Technical Service Bulletin

**UNUSUAL NOISE WHEN STARTING TO MOVE VEHICLE WHILE
STEERING WHEEL IS FULLY TURNED TO DRIVER-SIDE**

Bulletin No.: 06-002/20

Last Issued: 04/01/2020

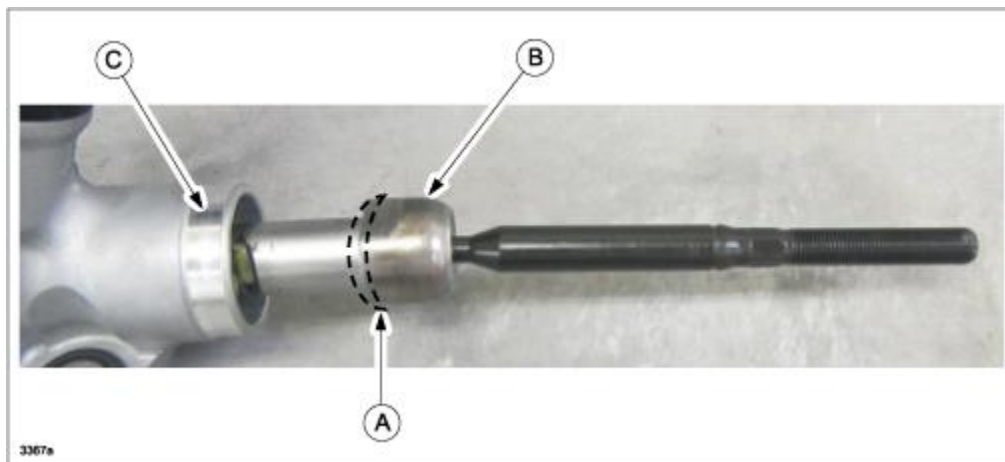
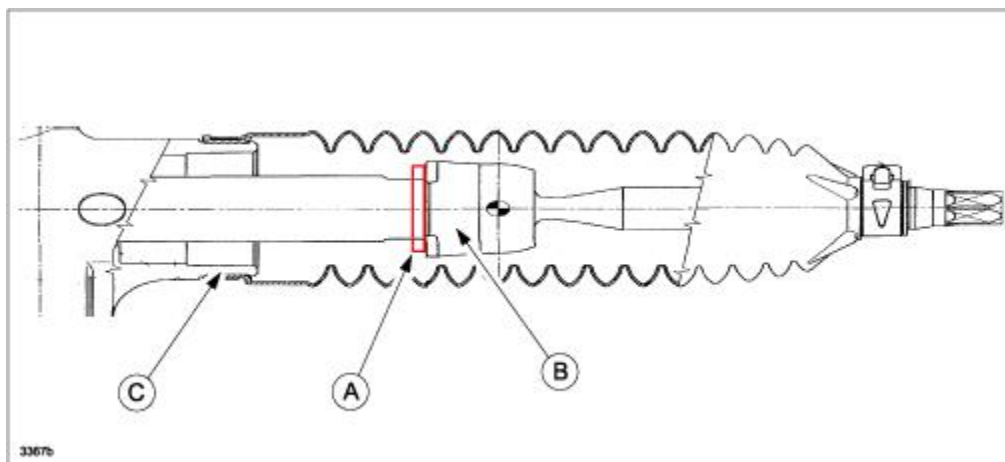
Some vehicles may exhibit an unusual noise (clacking) from under the front of the vehicle. This noise only occurs when starting to move the vehicle while the steering wheel is fully turned to the driver-side (left side for LHD vehicle and right side for RHD vehicle).

The noise is caused when the edge (A) of the inner ball joint (B) gets stuck with the steering gear housing (C).

To eliminate the noise, a spacer (A) has been installed between the inner ball joint (B) and the steering gear housing (C) (both sides) to prevent direct contact.

DRIVER SIDE

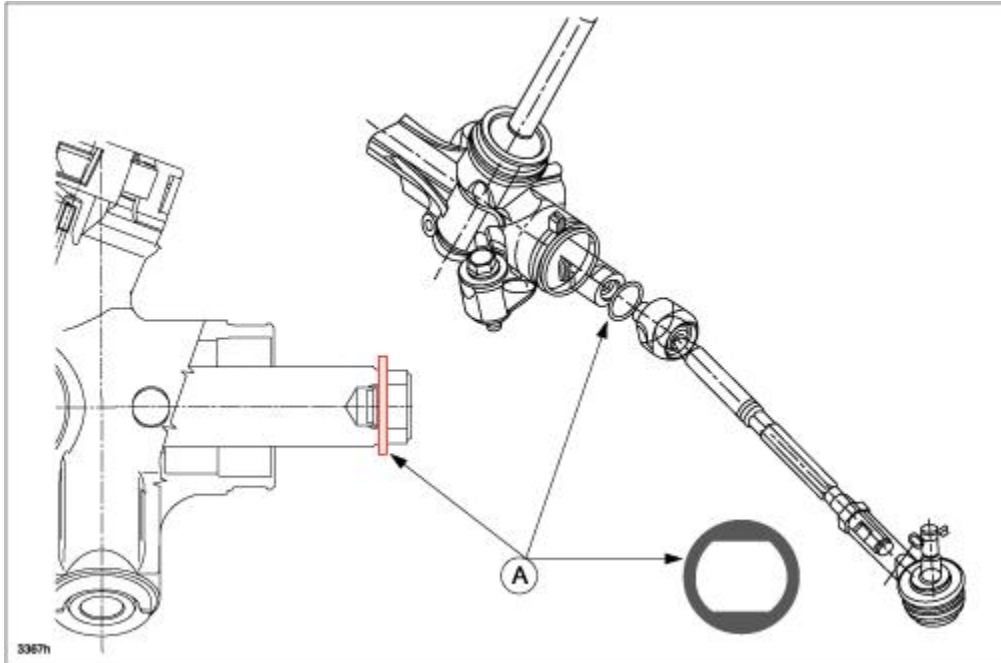
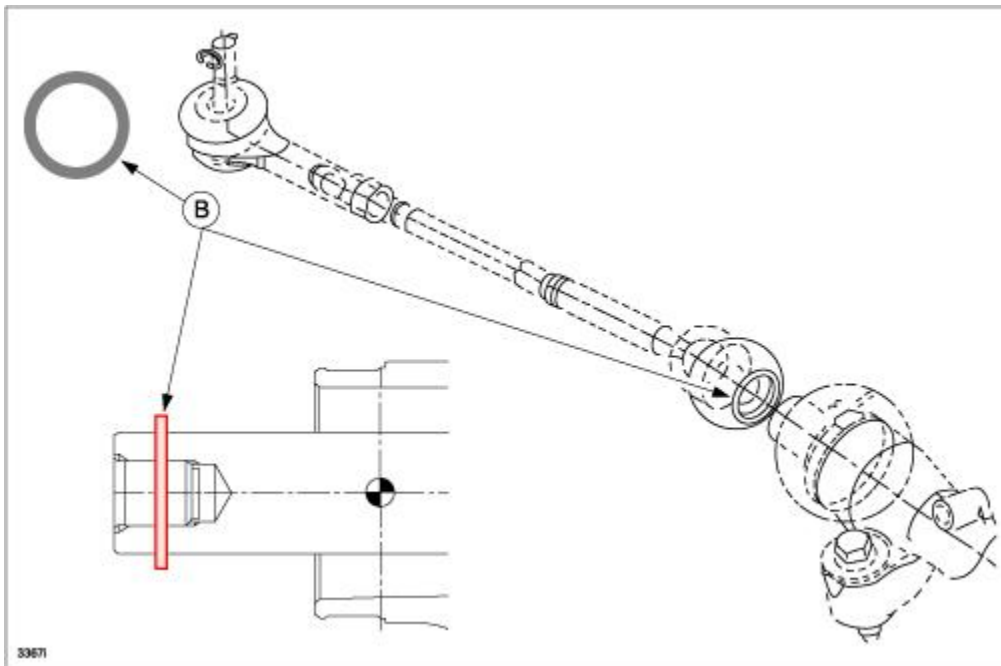
5. Install the driver side spacer (A) and passenger side spacer (B) onto the steering rack bar as shown below.

NOTE: Be aware that the shape of the driver and passenger side spacers are different.

NOTE: Both sides of each spacer are the same. There is no back or front side.

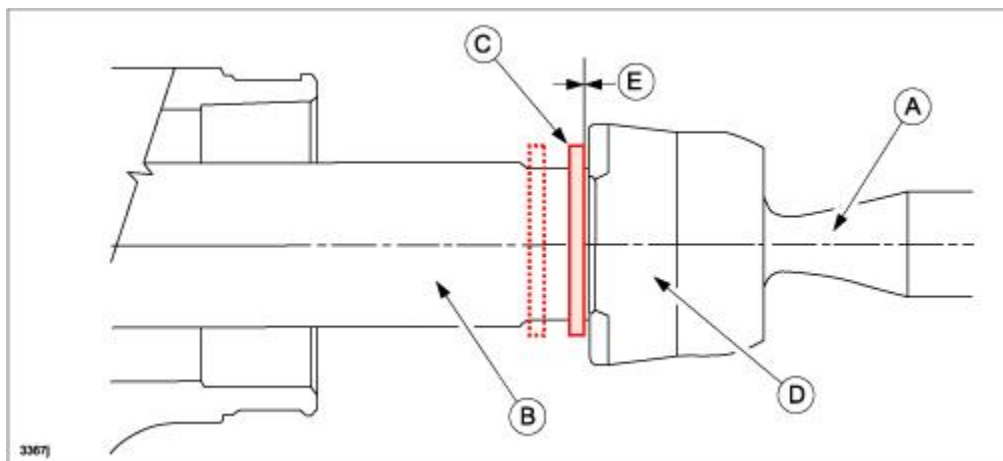
CAUTION: When tightening the tie-rod assembly (A) to the steering rack bar (B), be careful not to pinch the spacer (C) between the inner ball joint (D) and the steering rack bar (B).

NOTE: After installing the tie rod assembly (A), slide the spacer (C) so that it contacts the inner ball joint (D) with zero clearance (E) as shown below (both sides).

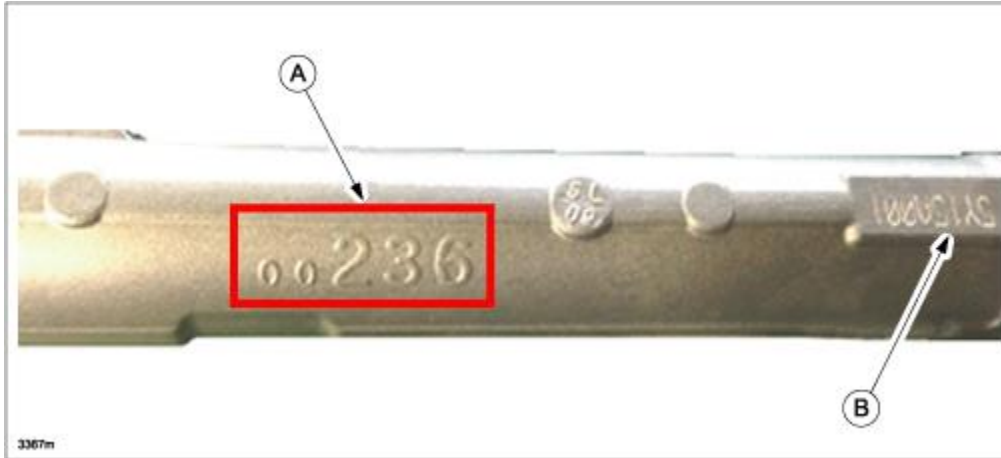
NOTE: CX-5 uses two (2) types of joint set (24 mm vs 26 mm) depending on the size of steering gear housing. Check the number cast on the steering gear housing (A) and find the size of the steering gear housing and the applicable joint set from the table below. Number cast (B) can be ignored.

Steering Gear Housing Diameter	Number on Housing	Applicable Joint Set Part Number	Vehicle Production Date
24 mm	00125	K0Y6-32-24XA	BEFORE 08/07/14
26 mm	00236	K0Y0-32-24XA	AFTER 08/07/14
